Drawing Title			
PROPOSED PLANS			
LOWER GROUND AND GROUND			
North	Drawn	RW	Date
			SEPTEMBER 2019
			Scale
			1:100
Filename			
Job No	Drawing No	Revision	
1908	DA02	B

KELLEHER RESIDENCE
12 MONTPELIER PLACE
MANLY

PROPOSED ELEVATIONS

Drawing title			
PROPOSED SECTIONS			
North			
		Drawn RW	
		Date SEPTEMBER 2019	
		Scale 1:100	
		Filename	
Job No	Drawing No	Revision	
1908	DA05	B

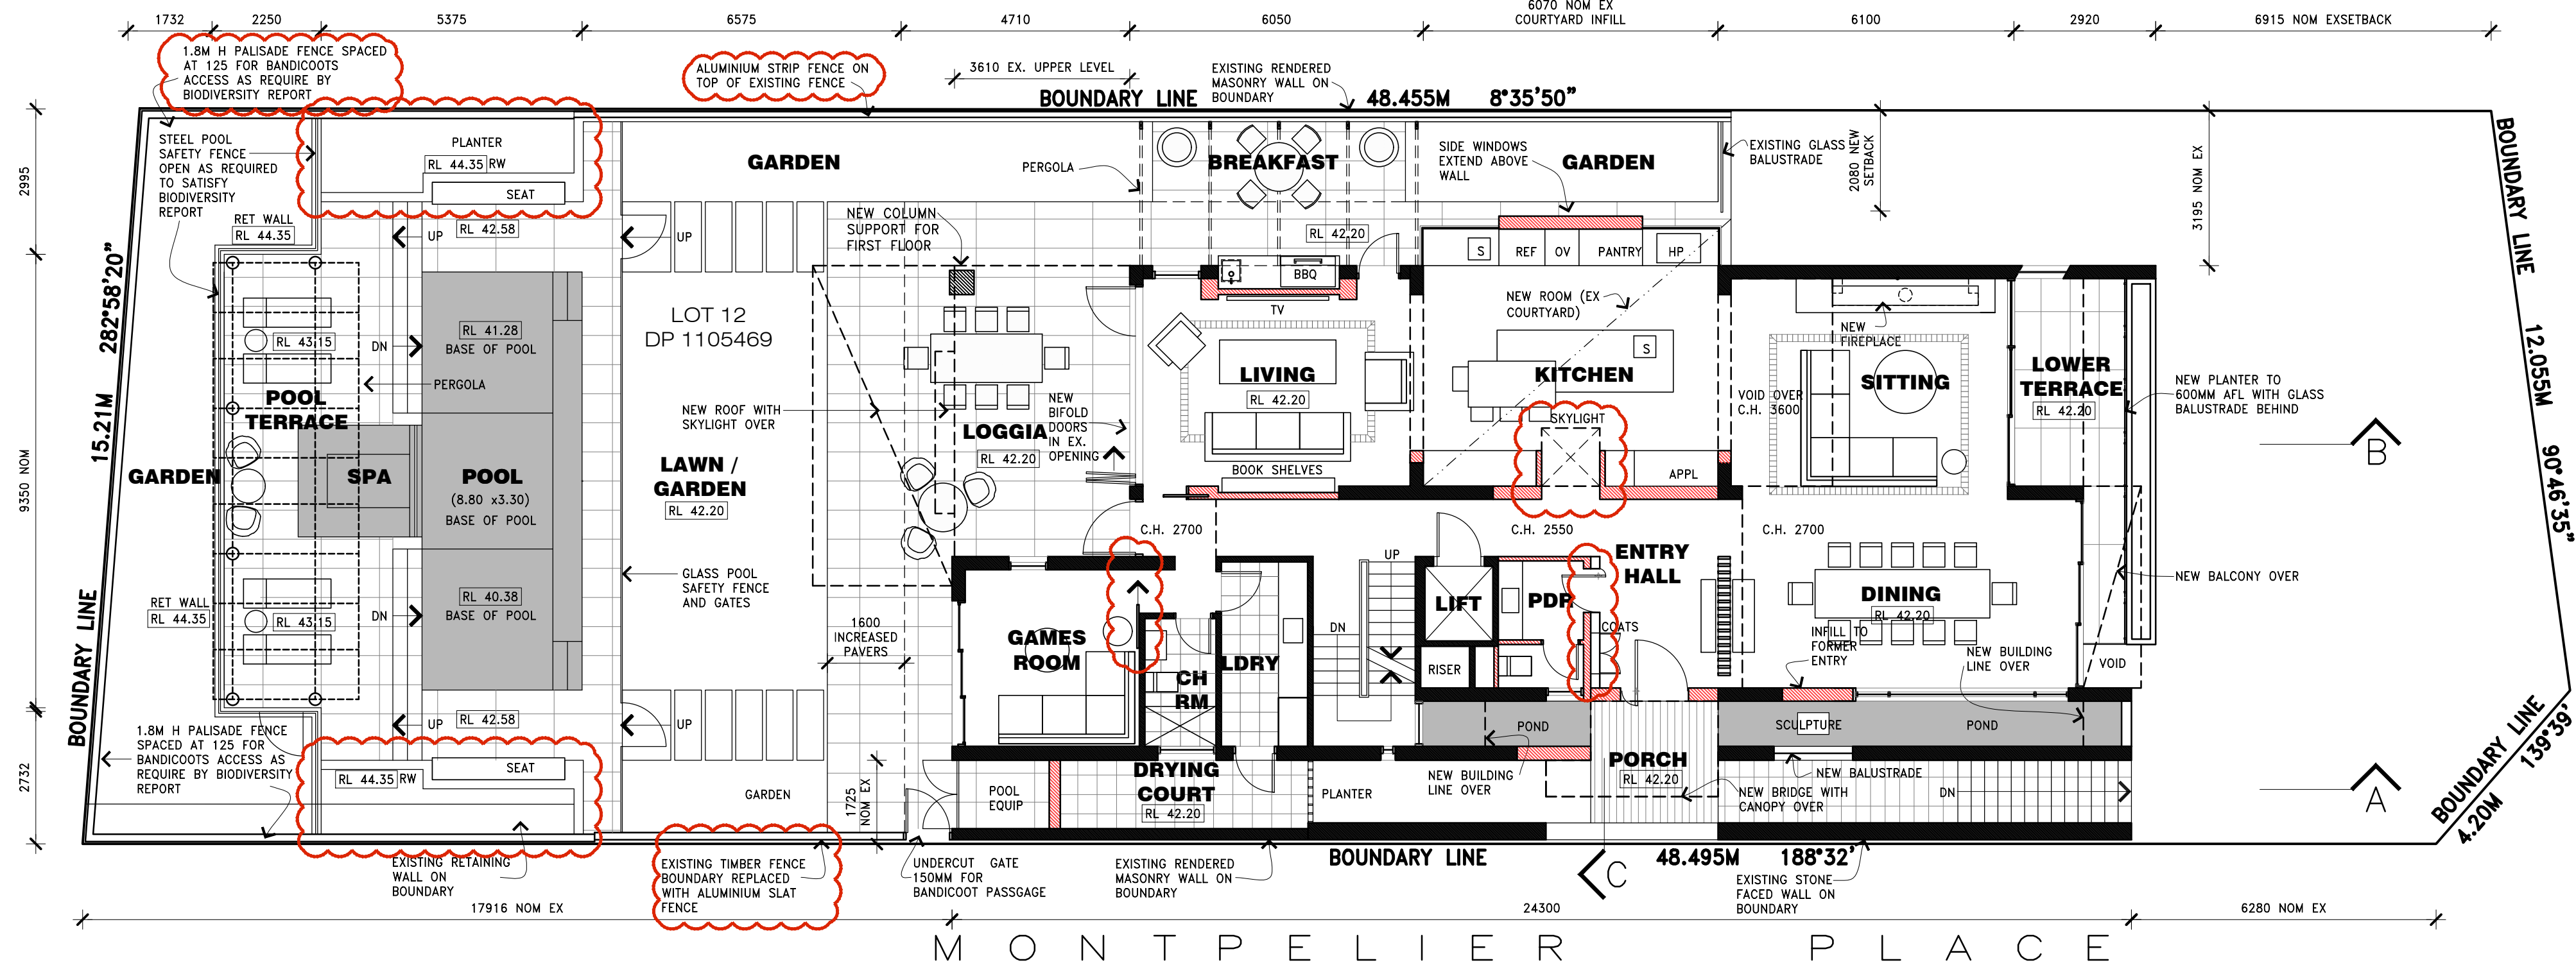
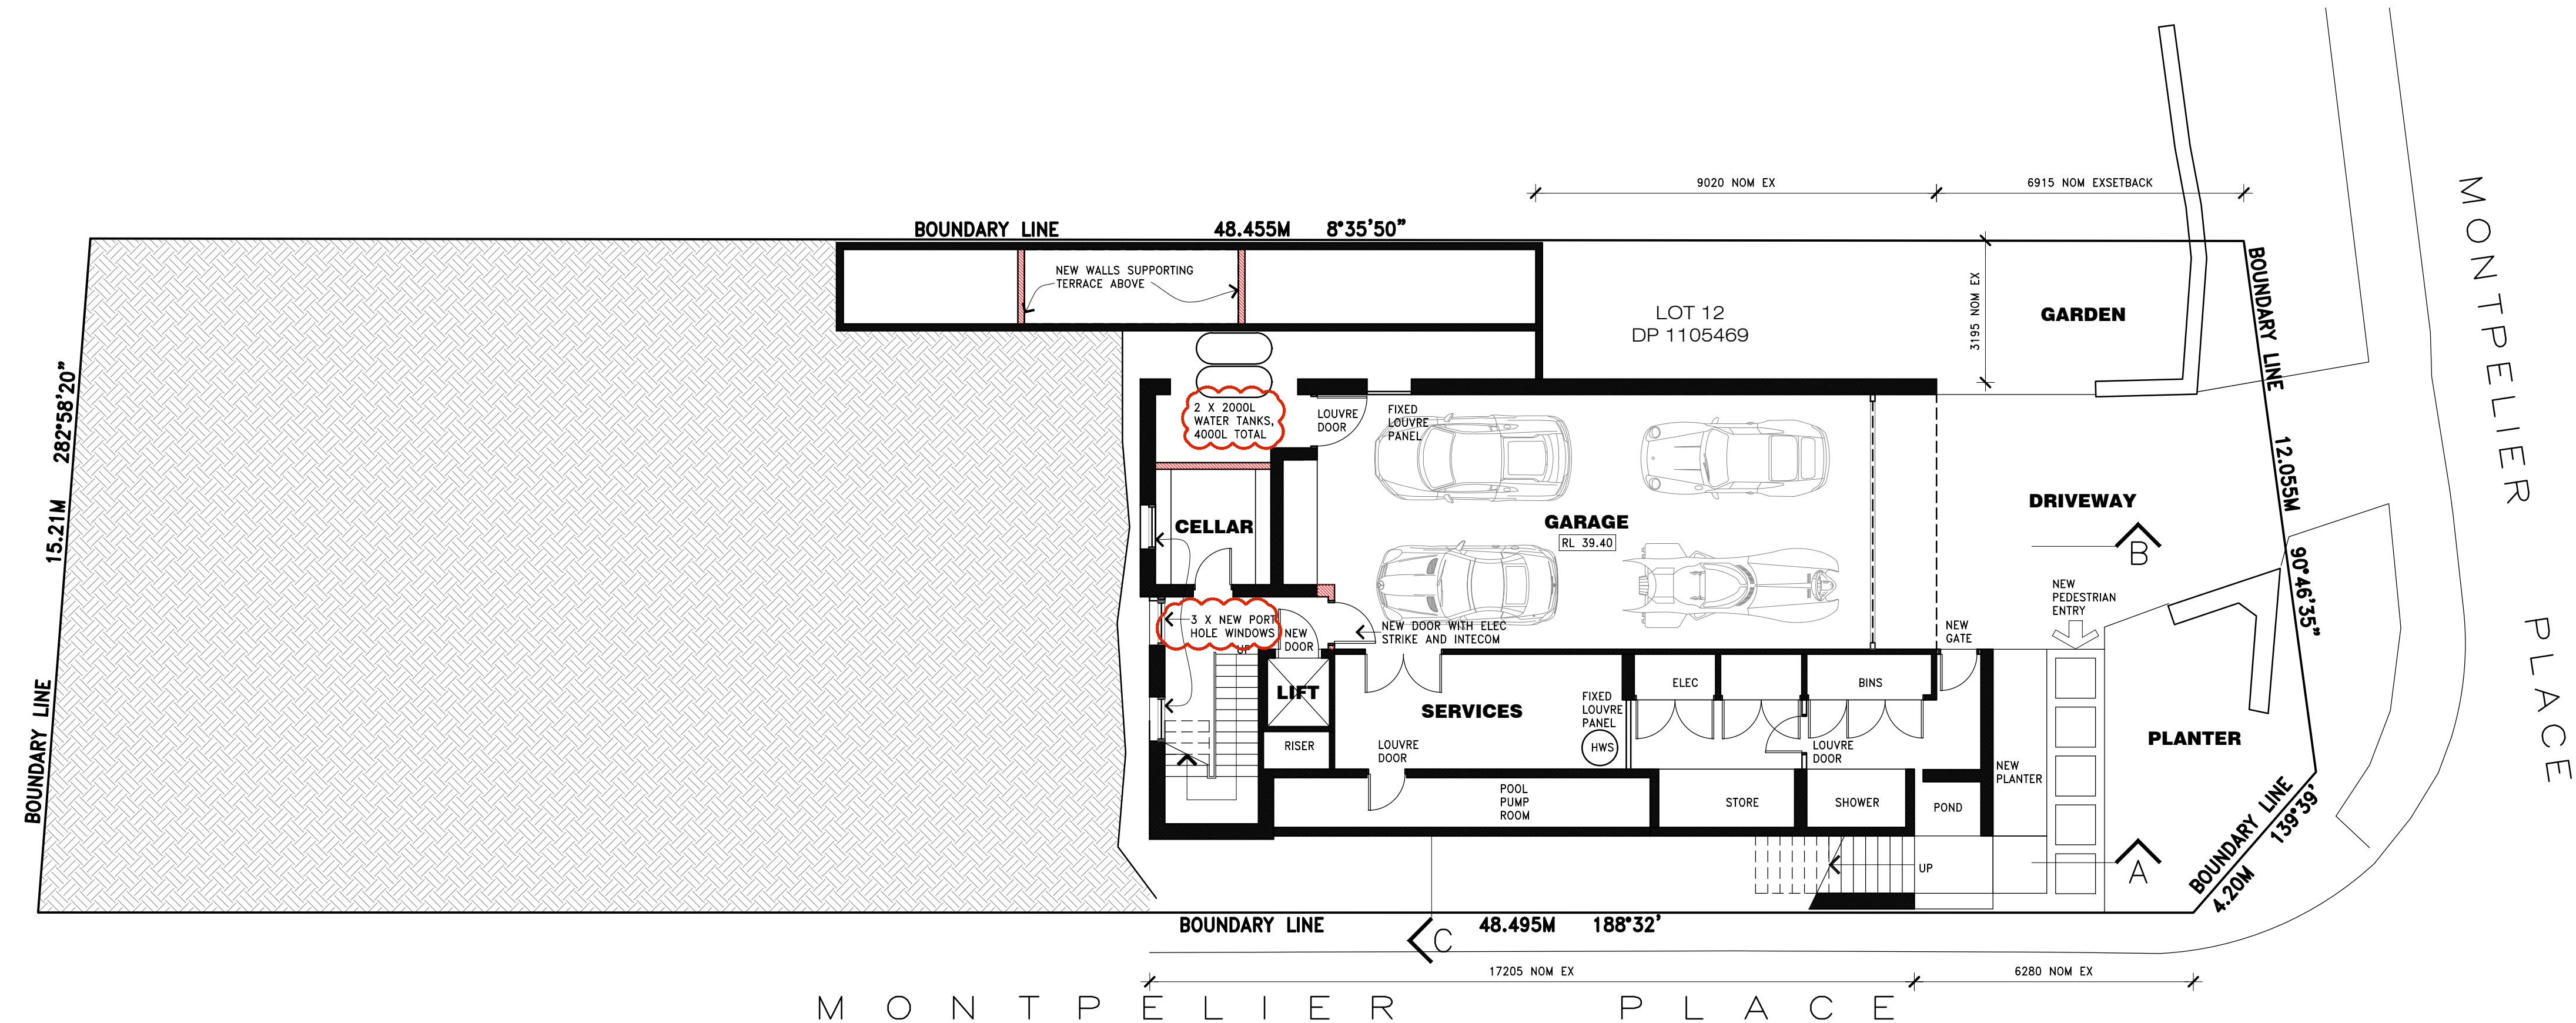
RW	10/08/21	Basement- porches added Basement- RW tanks relocated Ground-Kitchen walls changed, skylight increased Ground- cool cpd added to Entry Ground- no roof or retractable awnings to west terrace Ground- pool retaining walls adjusted Ground- Games Rm door changed to sliding Upper- spa added to terrace	
		Additional notes added: Upper- Bed 1 window east raised 200mm, operable louvers deleted, awning added Upper- skylight added to stairwell Upper-carrier duct removed, no linen cpd Upper-door to Bedroom 2 changed Upper- South Ensuite all lowered 300mm Upper- Bed 2 window screen altered Upper- redundant louvers removed General- new and existing sunshade canopy detail changed to all, battens General- Weatherflex cladding changed to painted Sycamore grooved panels General- boundary fences and retaining walls clarified, changed to aluminium and palisade where shown	
A	RW	22/9/20	Plaster added to front edge of balconies Balcony added to front of master bedroom Window added to east elevation Window added to west elevation BBQ relocated adj Breakfast Loggia / support for first floor S/W corner changed Fence added around pool terrace Pool and safety fencing redesign

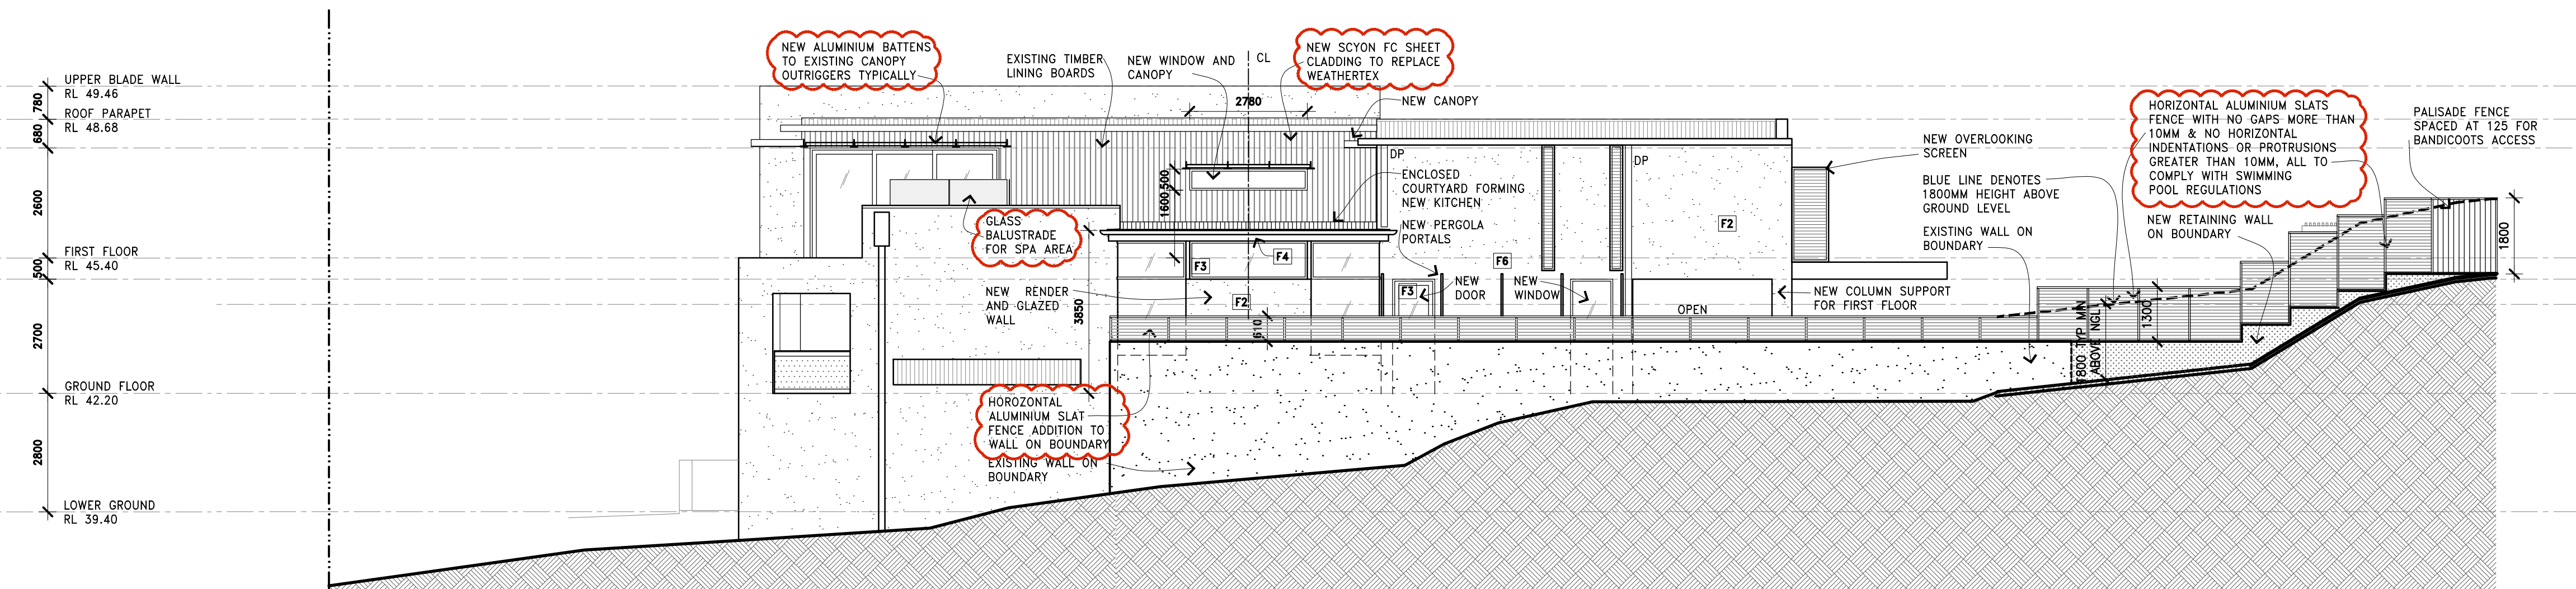
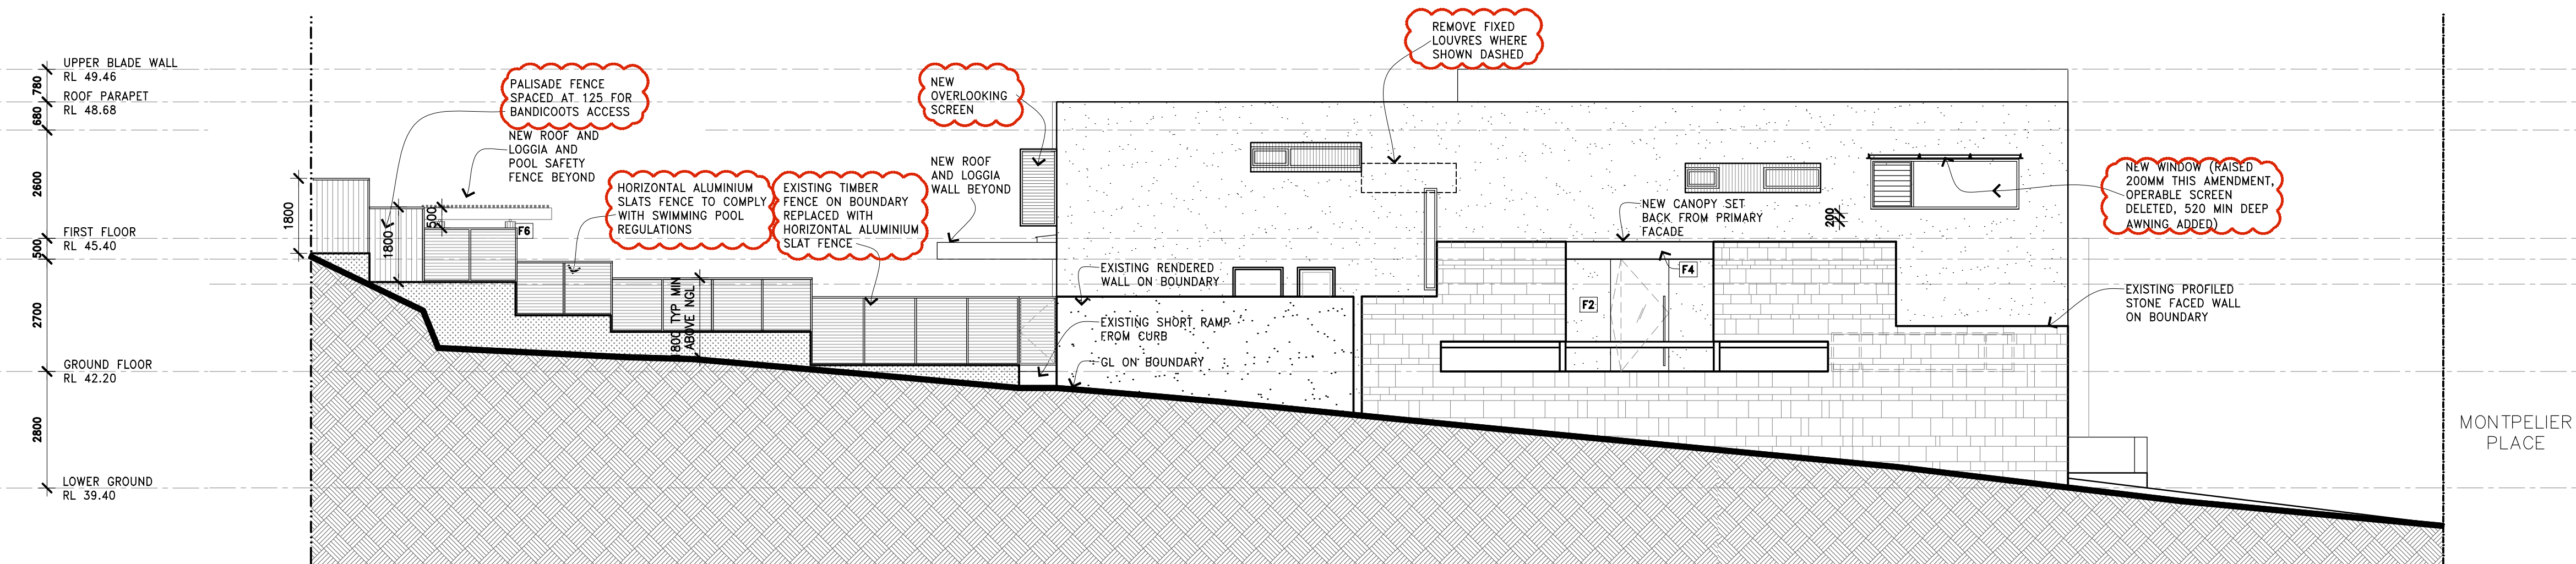
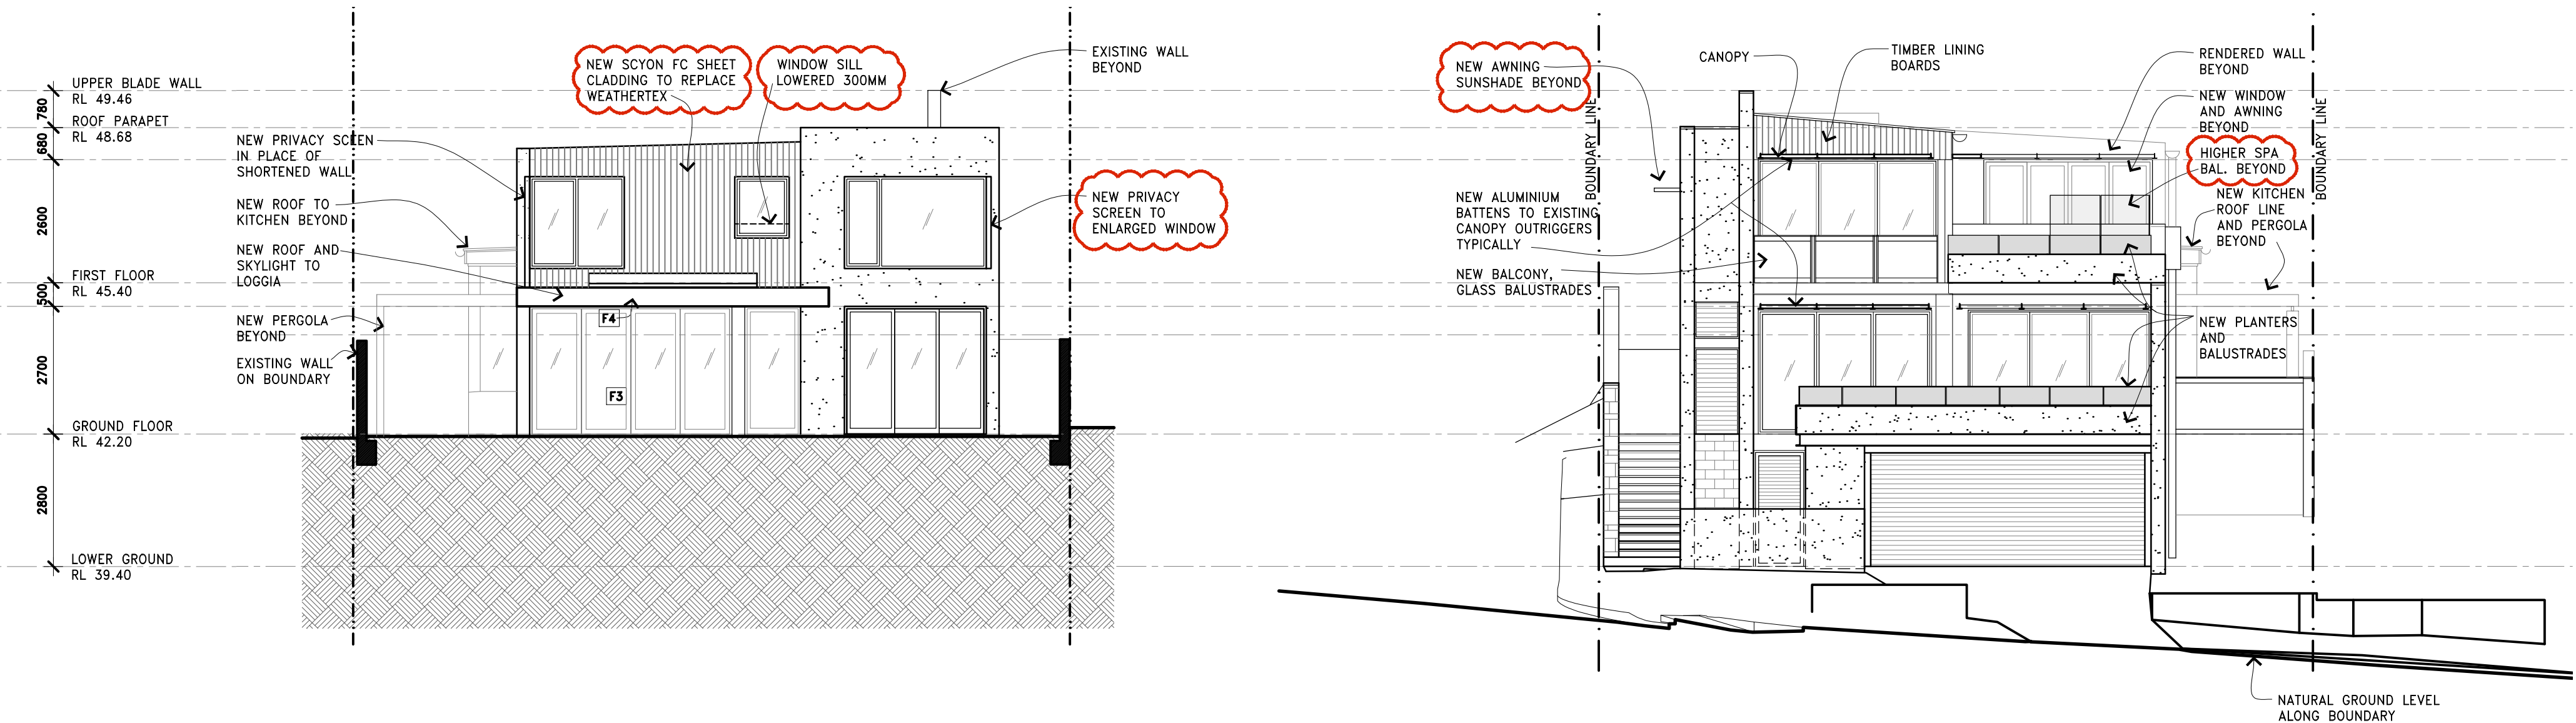
B RW 10/08/21	Basement- porches added Basement- RW tanks relocated Ground-kitchen walls changed, skylight increased Ground- east cpd added to Entry Ground- no roof or retractable awnings to west terrace Ground- pool retaining walls adjusted Ground- Games Rm door changed to sliding Upper- spa added to terrace, balustrades added
A RW 22/9/20	Upper- Bed 1 window east raised 200mm, operable louvers deleted, awning added Upper- skylight added to stairwell Upper-corridor duct removed, no linen cpd Upper-door to Bedroom 2 changed Upper- South Ensuite sill lowered 300mm Upper- Bed 2 window screen altered Upper- redundant louvers removed General- new and existing sunshade canopy detail changed to al. batten General- Weathertex cladding changed to painted Scyon grooved panels General- boundary fences and retaining walls clarified, changed to aluminium and palisade where shown Plaster added to front edge of balconies Balcony added to front of master bedroom Window added to east elevation Window added to west elevation BBO relocated adj Breakfast Loggia /support for first floor S/W corner changed Fence added around pool terrace Pool and safety fencing redesign
